Access Compliance Report

Public Rights-of-Way

(Curb Ramps)

Intersection ID: N/A	Main Street: SOUTHMORE_DR	Cross Street: HOUSTONFIELD CT	Location: NE
ADA ID: D0A3CF19748D	Ramp Type: Perp	Initial Pass/Fail: Fail	Overall Compliance: No
Severity Score: 12.5			
Codes/Mitigation Info/Possible Solution		Field Measurements/Component Compliance

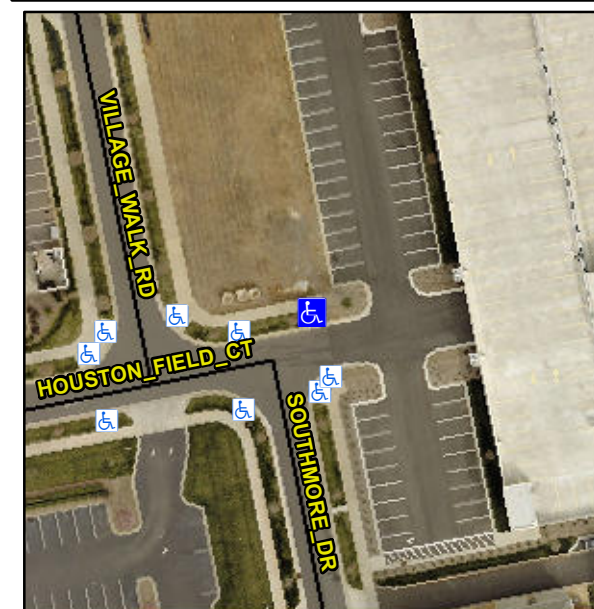
R304.2.2

Compliance	Description	Data	Compliance	Description	Data
N/A	Ramp Length (in)	94.0	No	Ramp Slope (%)	9.6
Yes	Ramp Width (in)	72.0	Yes	Ramp XSlope (%)	2.0
N/A	Flare Type LT	N/A	N/A	Flare Type RT	N/A
N/A	Flare Slope LT (%)	N/A	N/A	Flare Slope RT (%)	N/A
N/A	Flare Traversable LT?	N/A	N/A	Flare Traversable RT?	N/A
N/A	Landing Length (in)	N/A	N/A	DWS Provided?	N/A
N/A	Landing Width (in)	N/A	N/A	DWS Contrast?	N/A
N/A	Landing Slope (%)	N/A	N/A	DWS Length (in)	N/A
N/A	Landing X Slope (%)	N/A	N/A	DWS Full Width?	N/A
N/A	Landing Curb? (Y/N)	N/A	N/A	DWS Offset (in)	N/A
N/A	Shared Landing?	N/A			
N/A	Gutter Ponding?	N/A	N/A	Gutter Slope (%)	N/A
N/A	Gutter Lip Ht (in)	N/A	N/A	Gutter X Slope (%)	N/A
N/A	Painted X Walk1?	No	N/A	Painted X Walk2?	N/A
	X Walk 1 Direction	To S		X Walk 2 Direction	N/A
N/A	X Walk 1 Width (in)	N/A	N/A	X Walk 2 Width (in)	N/A
	X Walk 1 Slope (%)	1.7		X Walk 2 Slope (%)	N/A
	X Walk 1 X Slope (%)	4.7		X Walk 2 X Slope (%)	N/A

Remove & Replace Entire Ramp.
